The following comments are submitted to the New Mexico Environment Department for the **Sandia National Laboratories' Corrective Measures Implementation Report** (CMI Report) for the **Mixed Waste Landfill** that is a radioactive and hazardous waste dump contaminating Albuquerque's drinking water aquifer.

The following comments are submitted to the New Mexico Environment Department for the **Sandia National Laboratories' Corrective Measures Implementation Report** (CMI Report) for the **Mixed Waste Landfill** that is a radioactive and hazardous waste dump contaminating Albuquerque's drinking water aquifer from its unlined pits and trenches.

Technical Review of Appendix E,
Probabilistic Performance-Assessment Modeling of the
Mixed Waste Landfill at Sandia National Laboratories,
of the
Mixed Waste Landfill Corrective Measures Implementation Plan

RE: Notice of Deficiency: Mixed Waste Landfill RFI Report

Figure 1. Map of the Sandia Mixed Waste Landfill (Sandia MWL dump) showing the monitoring well network in 2007 of the six monitoring wells MW1 to MW6 and the background water quality well BW1 500 feet south of the dump.

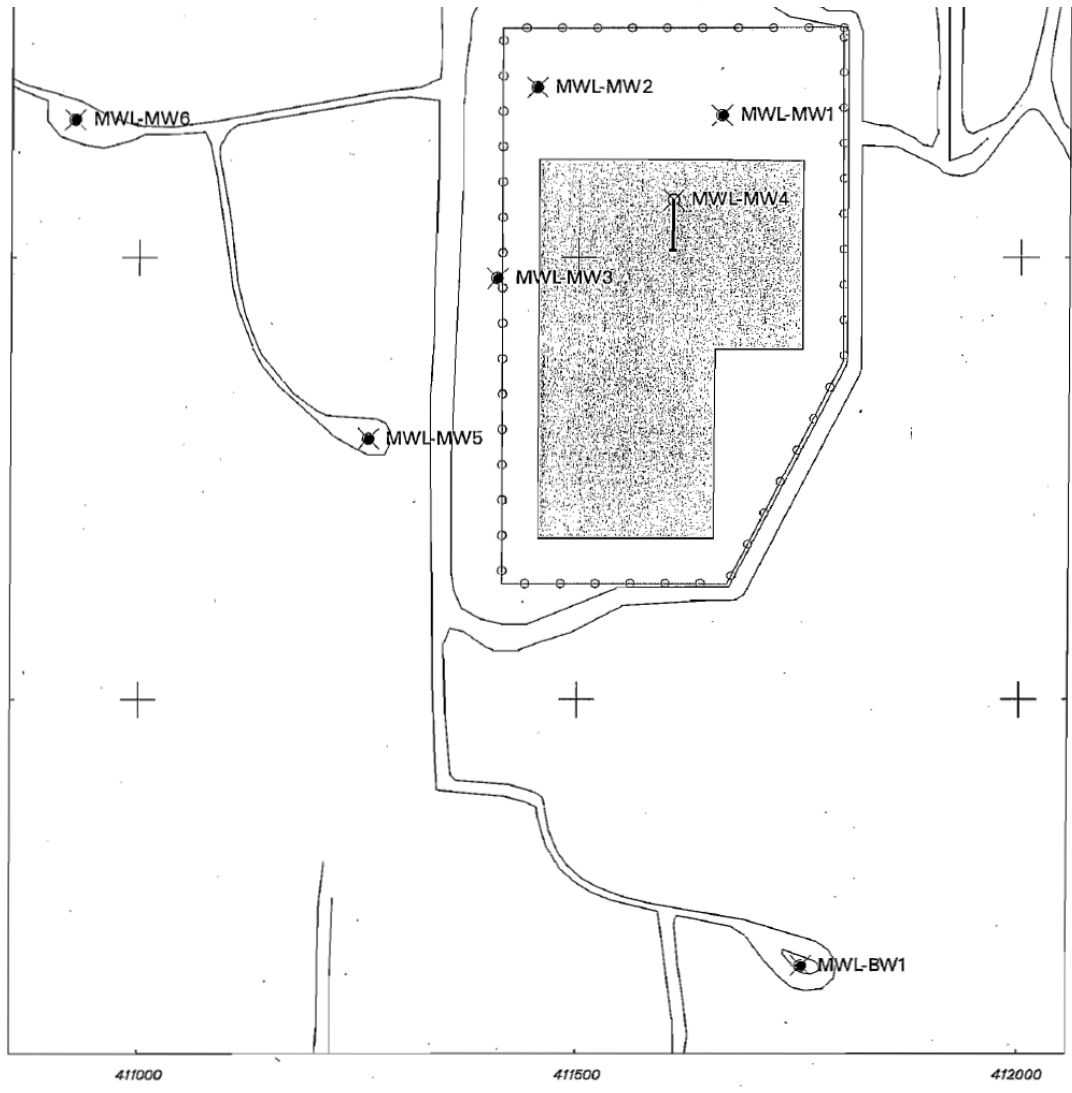
- The current monitoring well network at the Sandia MWL dump includes the six unreliable contaminant detection monitoring wells MWL-MW4, -MW5, -MW6, -MW7, -MW8 and -MW9 and the background water quality monitoring well MWL-BW2. The locations of the seven wells are shown on Figure 3 (see attached). The six contaminant detection monitoring wells in the current network require replacement because they do not meet the intended purpose to 1). monitor contamination at the water table below and downgradient from the MWL dump, 2). measure the elevation of the water table and 3). accurately determine the direction and speed of groundwater travel at the water table below and hydraulically downgradient from the MWL dump. The NMED HWB has not, but should enforce the requirement in the NMED Sandia Consent Order and RCRA for replacement of the six defective monitoring wells in the current network.

Figure 2. Schematic of the Monitoring Wells and the Hydrogeologic Setting at the Sandia MWL dump. The permeable sands and gravels in the Ancestral Rio Grande "A" Deposits (ARG deposits) are the valuable groundwater resource for Albuquerque and the surrounding region.

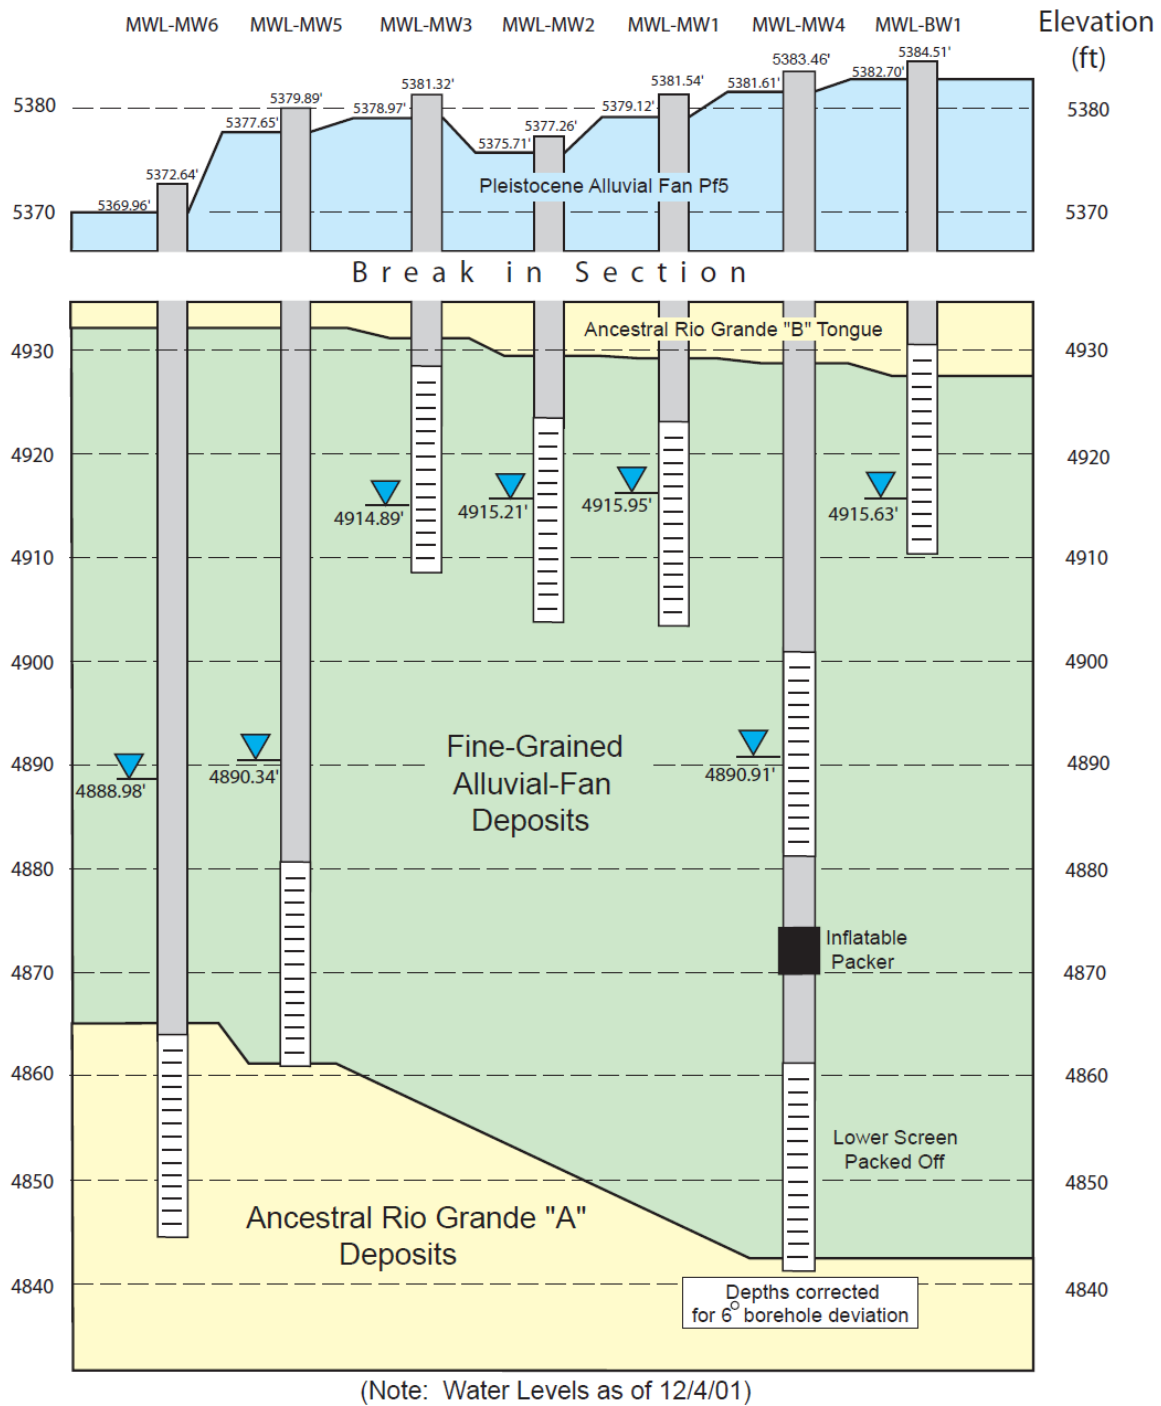
- There are two zones of saturation below the Sandia MWL dump that require networks of monitoring wells. A reliable network of monitoring wells was not installed in either of the two zones. Figure 2 (see attached) is a geologic cross section that shows
